Access Compliance Report

Public Rights-of-Way

Intersection ID: 11423	Main Street: S_SUMMIT_AV	Cross Street: W_4TH_ST_EXT	Location: S
ADA ID: 2D6C3436F3E5	Ramp Type: BlendTrans1	Initial Pass/Fail: Pass	Overall Compliance: No
		Severity Score: 0

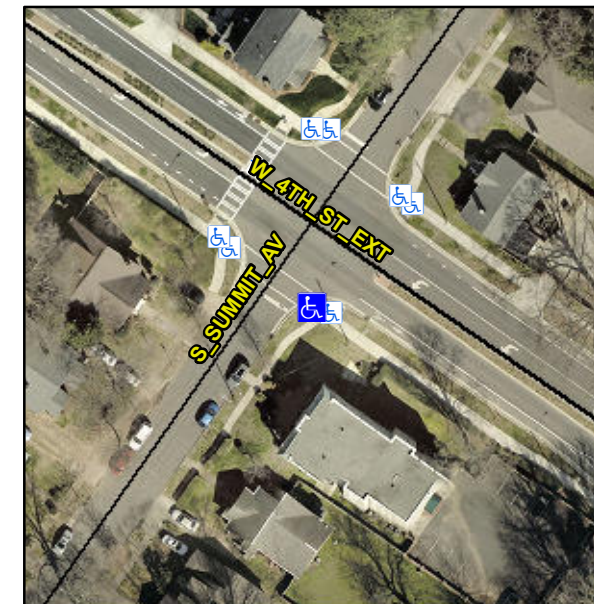
Possible Solutions:

Remove & Replace Detectable Warning System.

PROW/ADA:

R305.2
